Building Block #2 Impacts on the Emission Rate Goals for Arizona Under EPA's Clean Power Plan Proposal

Problems Associated with Environmental Re-dispatch in Arizona

Figure 1. Impact of EPA’s Interim and Final Goals in Arizona

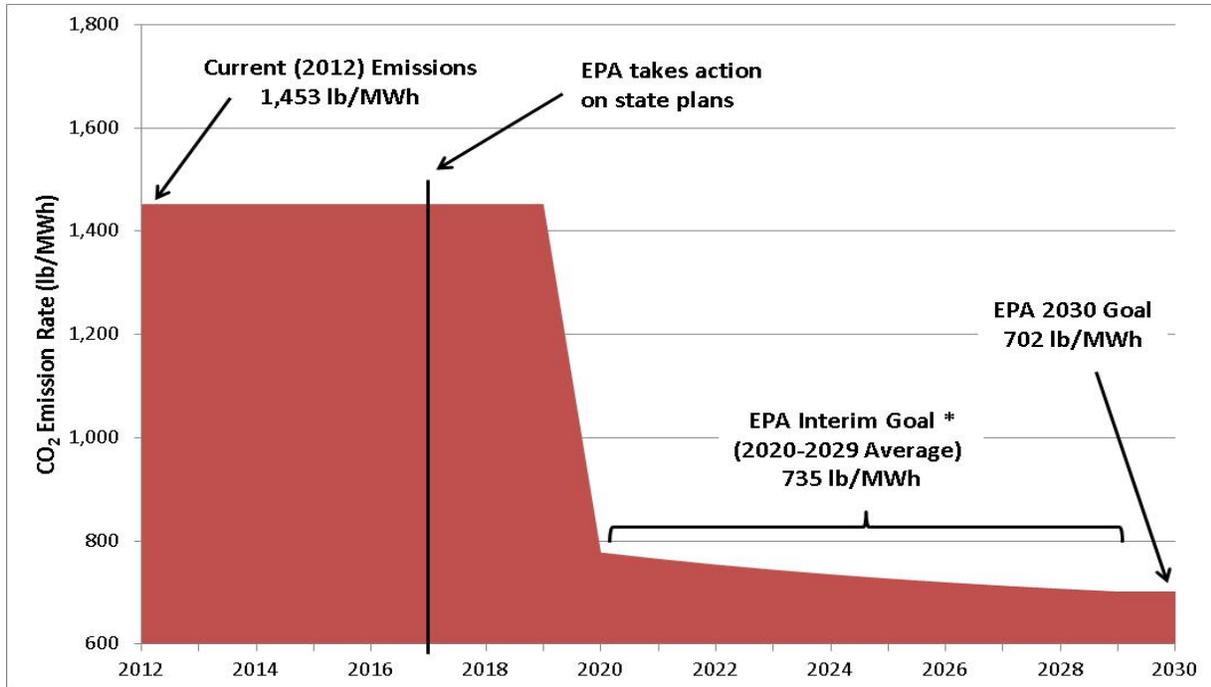
would be replaced with NGCC generation by 2020. Figure 1 demonstrates the dramatic impact that BB2 has on the compliance glide path for Arizona.

Figure 3: 2012 SRP Retail Firm Load Profile

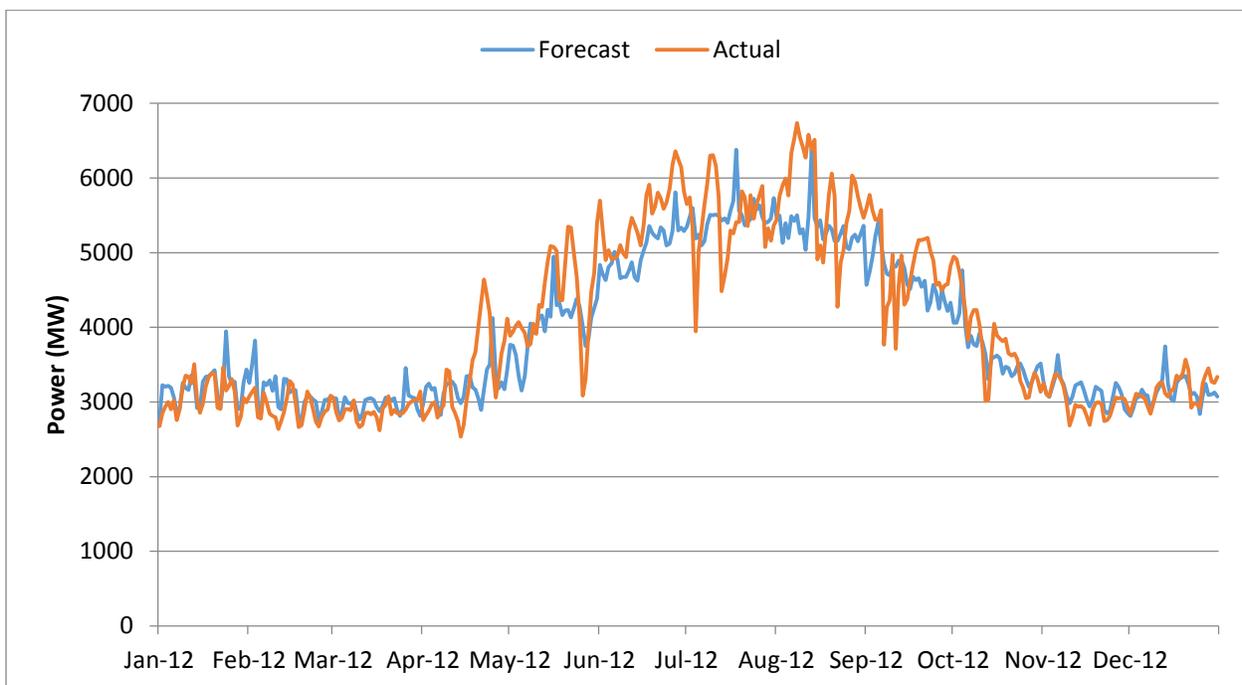
For example, Figure 3 illustrates peak demand for electricity (“retail firm load”) from SRP’s system in 2012. Peak electricity demand can be more than twice as high as base demand in the off-peak months. Furthermore, while forecasted values trend well with actual values, utilities still cannot predict exactly when the highest peak will occur and how high that peak will be.

Figure 4: Resources Needed by SRP to Meet Peak Demand on August 8, 2012

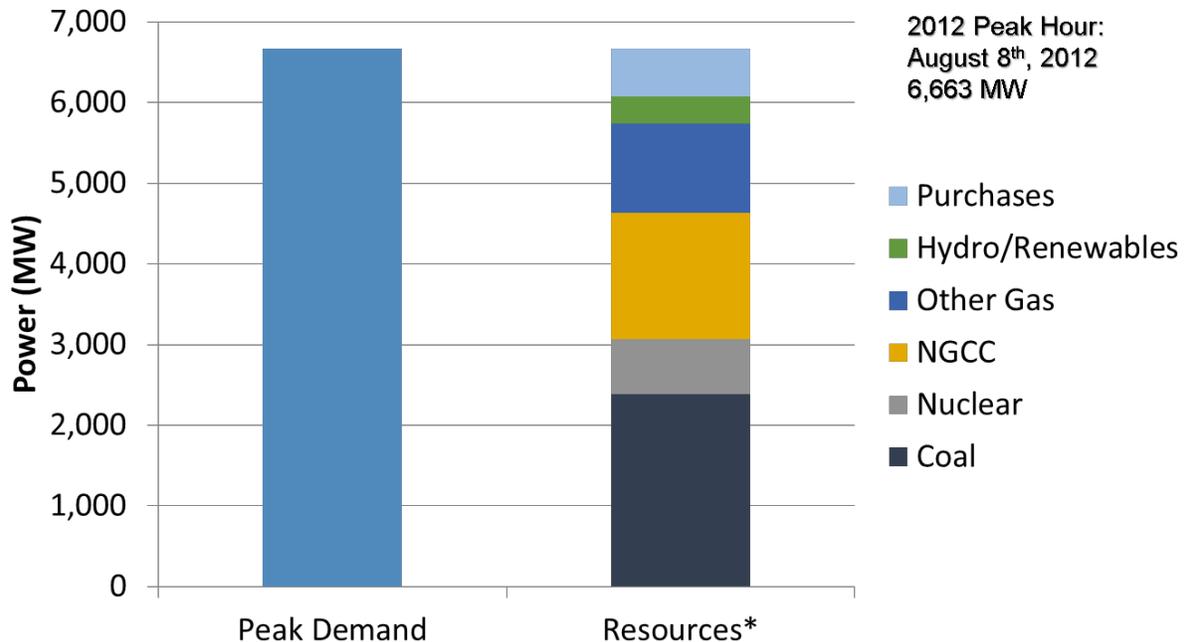
In 2012, SRP reached its highest peak hourly load value of 6,663 megawatts on August 8. Figure 4 shows a breakdown of the generating resources that were operating during that peak hour to meet customer demand. During this hour, all available generation resources, including coal and OG steam plants, were being utilized at full capacity to meet that peak demand. Even with all SRP system resources being utilized at full capacity, SRP was still forced to purchase electricity on the open market to meet peak demand and Federally-required reserve requirements.

It is clear that without coal and OG steam resources, SRP would not have been able to meet the peak electricity demand without purchasing a significant amount of electricity from the short-term market in addition to what is already being purchased, which is a costly and risky endeavor, assuming that such power is even available. Arizona is not the only state in the Western U.S. that experiences these high peaks in the summer. As such, other utilities are likely to be competing for that same power, at the same time, on the short-term market.

Figure 5: Potential Re-Dispatch of SRP Generation Resources

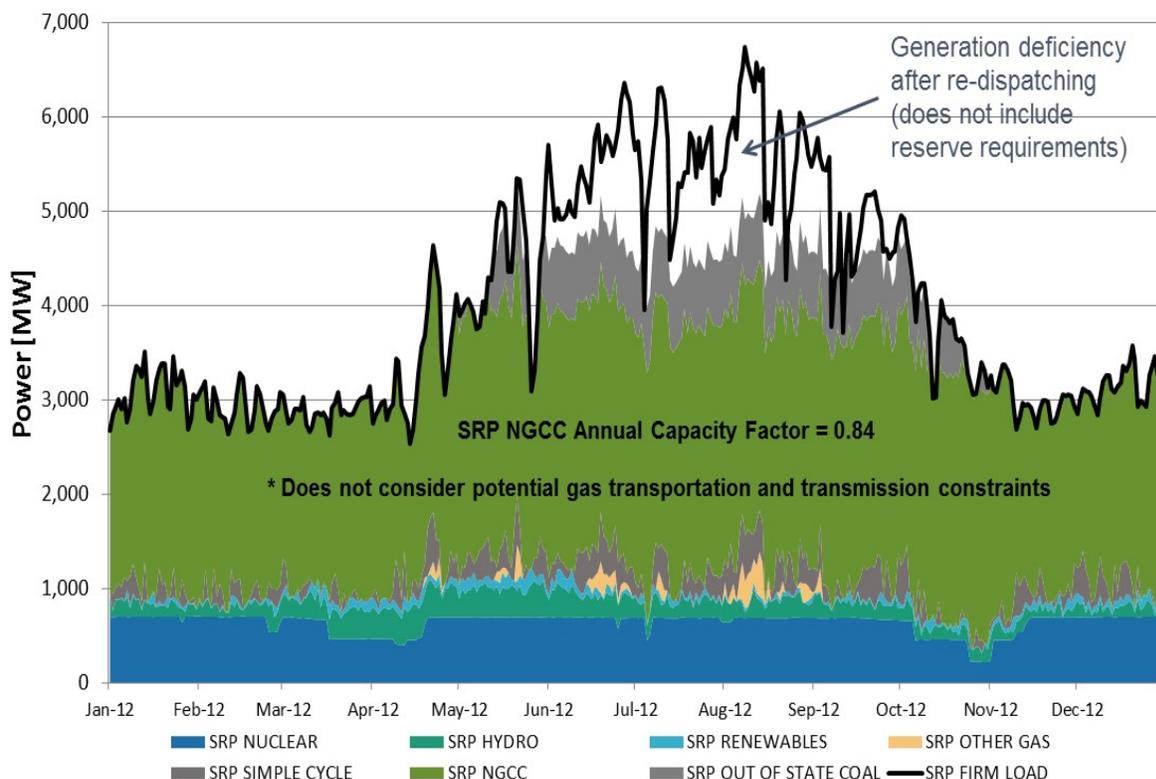
While Figure 4 shows a single peak hour, Figure 5 provides an annual look at how SRP's generation resources would fall short if SRP were required to replace all existing coal and OG steam generation with NGCC generation. For illustrative purposes, SRP assumed a 100% NGCC capacity factor on an hourly basis, which equates to 84% on an annual average basis. This level of dispatch exceeds EPA's assumption of 70% on an annual average basis.

As Figure 5 demonstrates, even with an extremely aggressive NGCC re-dispatch assumption, SRP would still have significant shortages in generation for several months in the summer. This lack of generation would be further aggravated if out-of-state coal resources also are eliminated due to compliance with the Clean Power Plan.

Figure 6: Merchant NGCC Plant Utilization in Arizona

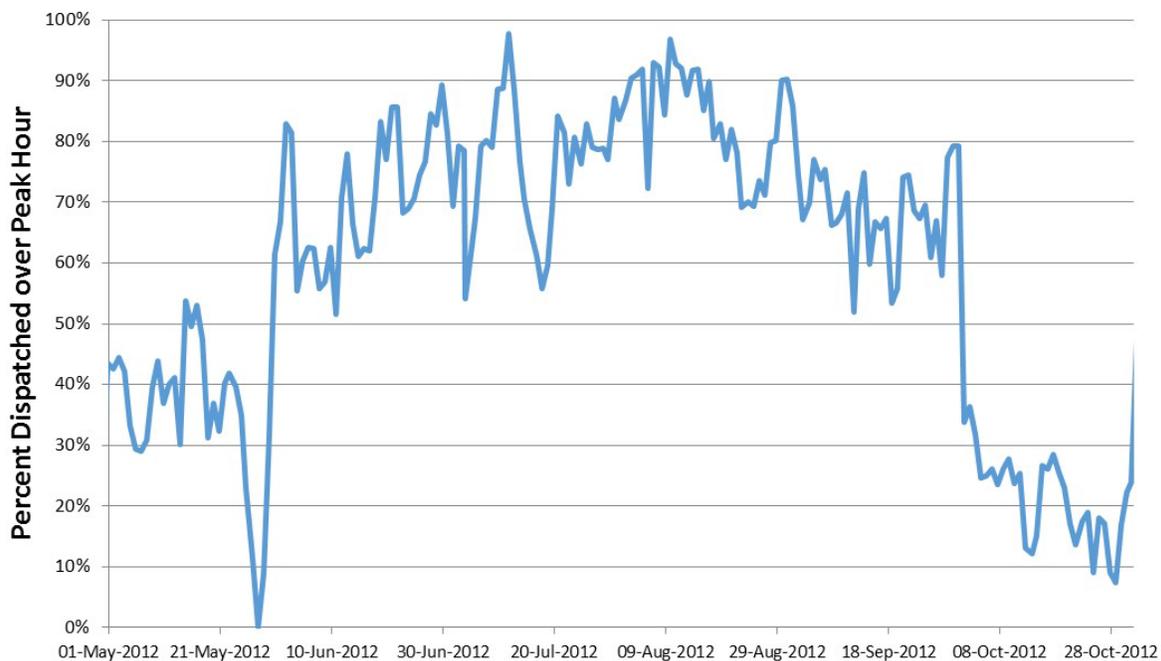
Setting aside constraints on merchant use posed by their business structure, SRP still investigated the availability of merchant NGCC plants within Arizona using data obtained from EPA's Clean Air Markets Database, which was used to determine hourly generation loads. Figure 6 shows the level at which merchant NGCC plants were dispatched over the peak hour on each day in the summer of 2012. All of the merchant plants in Arizona often operate at full or nearly full output during peak months to meet demand not only in Arizona, but in neighboring states as well. As such, utilities cannot rely on any significant amount of merchant generation in long-term planning to meet system demand requirements during peak summer demand periods. It should further be recognized regional peak demands have been increasing and are projected to continue to increase. Therefore, even if there was currently a small surplus of regional capacity, it will quickly be absorbed by load growth and already announced coal and nuclear plant retirements, such as Units 1, 2 and 3 at the Four Corners Power Plant and all units at the San Onofre Nuclear Generating Station.

SRP's analysis indicates that Arizona cannot solely rely on existing NGCC capacity to meet peak demand because these facilities are already being fully utilized in certain hours of the year to serve regional loads. Coal and OG steam plants provide vital capacity during summer months, and that capacity must remain available to ensure system reliability during periods of peak demand. Coal plants cannot be run for a few hours a day to meet peak load; on the other hand, running them as baseload units in only the summer months to meet peak demand does not allow the state to meet its interim goal.

Figure 1

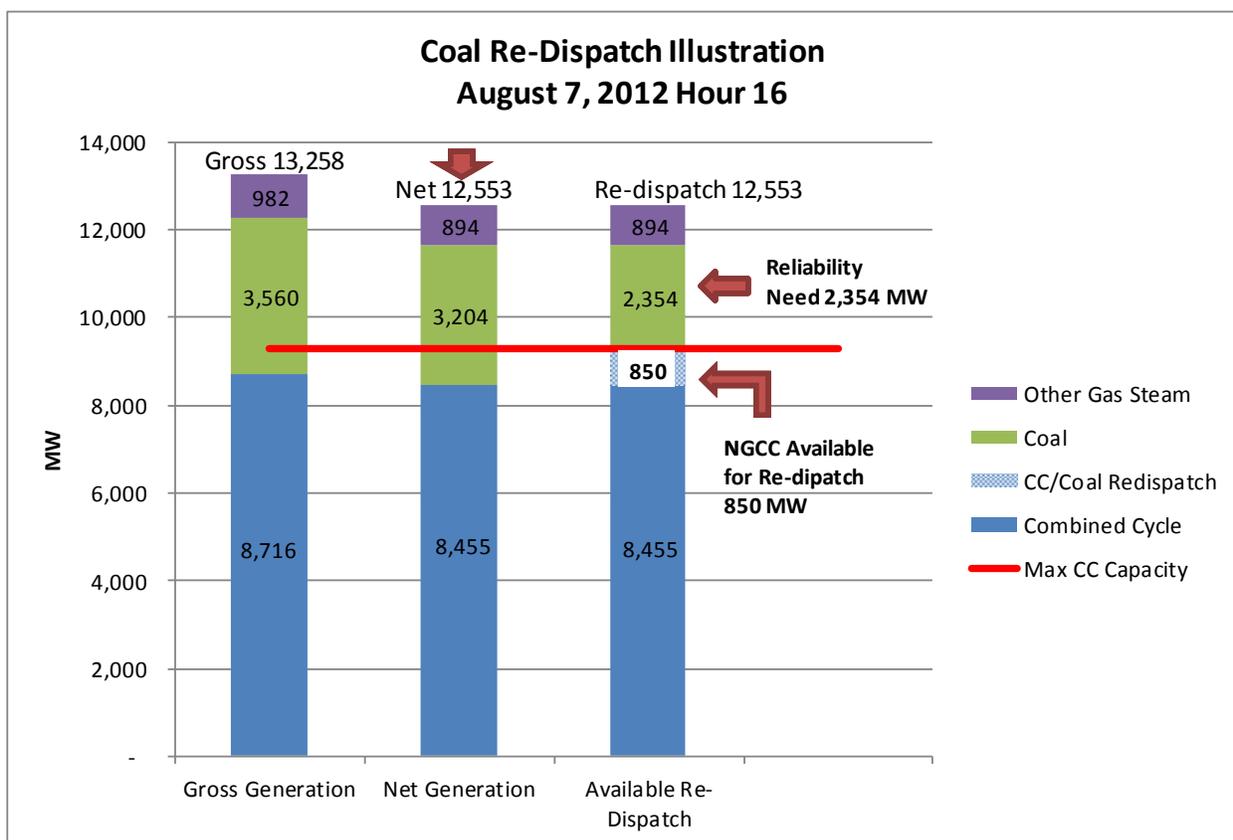
Figure 1 below shows that on August 7th, hour 16, 2012, Arizona NGCCs were generating 8,455 MW (net) and the coal and gas steam units were generating 4,098 MW (net). In order to re-dispatch all coal and gas steam with NGCC generation as assumed by the EPA, the NGCCs would have to be operating at 12,553 MW (8,455 MW + 4,098 MW). The maximum capacity assuming all units are fully available, however, is only 9,305 MW, a difference of 3,248 MW. Thus, only 850 MW of the 4,098MW of required capacity is available for re-dispatched in this hour, leaving 3,248 MW of demand that would still need to be met. This suggests that when calculating Arizona’s emission goal, portions of coal and gas steam cannot be re-dispatched to NGCC and must be factored into the carbon rate goal.

Figure 2

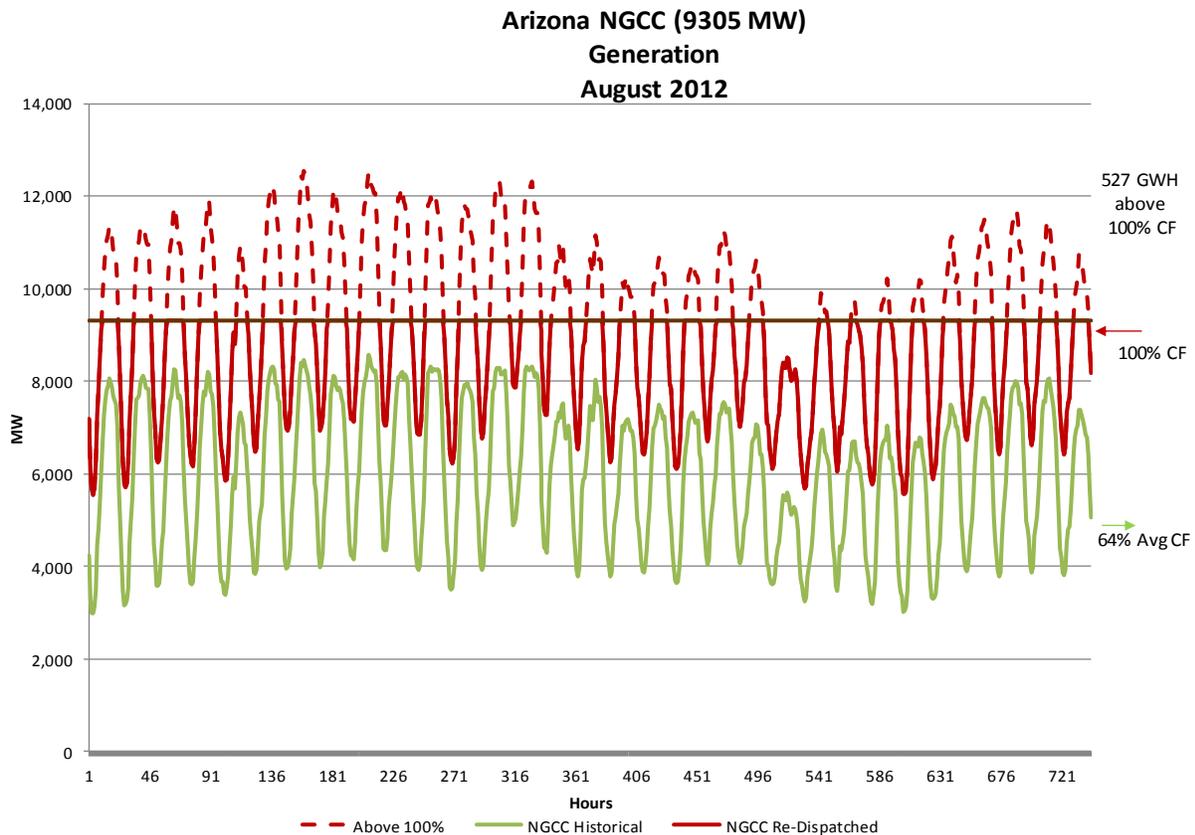
Figure 2 shows the results of this analysis for the month of August (744 hours). Actual hourly generation values for the Arizona NGCCs are indicated by the green line. Additional generation that would be required by NGCCs due to the re-dispatch of coal and natural gas steam-fired generation during the same period was added to the NGCC generation to replicate the re-dispatch as proposed by the EPA. These values are indicated by the red line. The figure also shows the maximum possible generation of the NGCCs during the summer months (100% capacity factor). As indicated by the dashed red line, nearly half of the time during August 2012 the demand that would normally be provided by coal and gas steam-fired generation exceeds the capacity of all NGCC in Arizona. This means that additional capacity is required to serve load beyond the existing NGCCs. August contains the largest number of occurrences when re-dispatch would require additional capacity; however, the same phenomenon occurs during the months of May through October. As a result, if all coal units were retired as modeled by the EPA, Arizona could face serious reliability issues in a significant number of hours throughout the year.

Figure 3

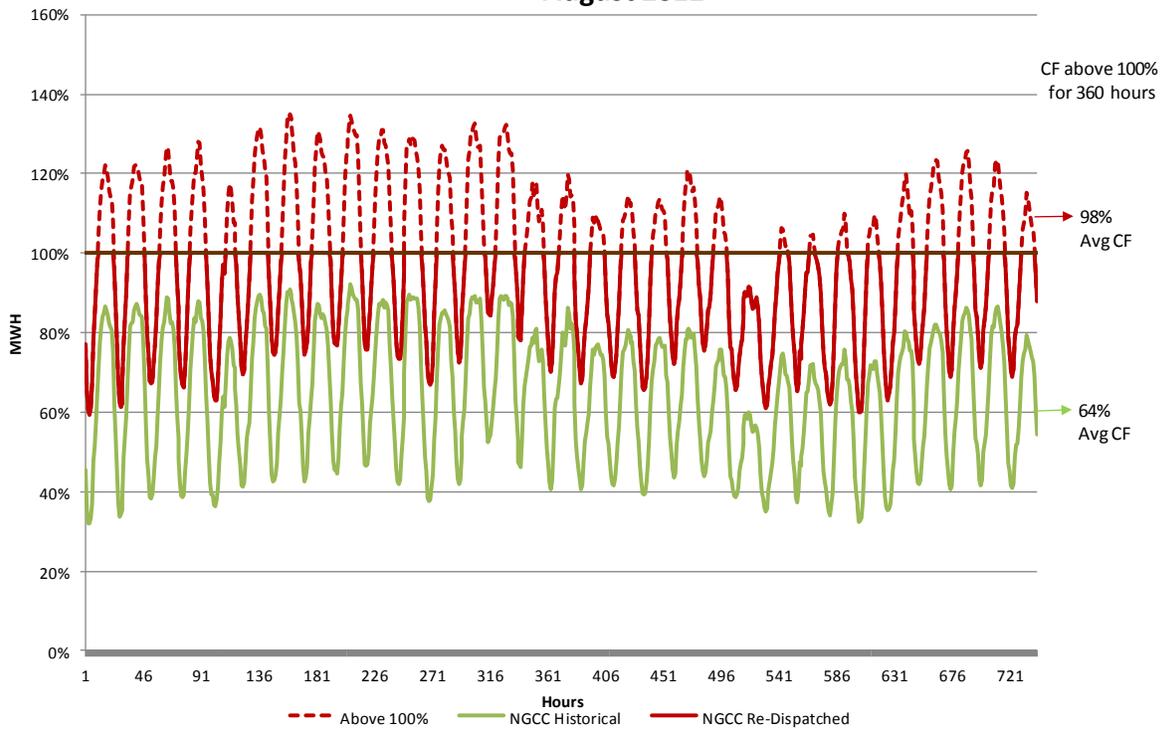
Figure 3 provides a similar illustration. The green line in Figure 3 represents the actual capacity factor during the month of August 2012 for NGCC located in Arizona. The red line shows the increase in the capacity factor of NGCC with the re-dispatch of the state’s coal generation. The re-dispatch capacity factor shows over 360 hours during the month where the demanded generation exceeded the available generation. During this period, the average capacity factor for all NGCC in Arizona would have to increase from 64% to 98%, which far exceeds the 70% cap proposed by the EPA. Because of the substantial increase in electrical demand in Arizona during peak times, the annual average capacity factor of NGCC cannot be used as a basis for determining the additional capacity NGCC can supply during peak demand periods.
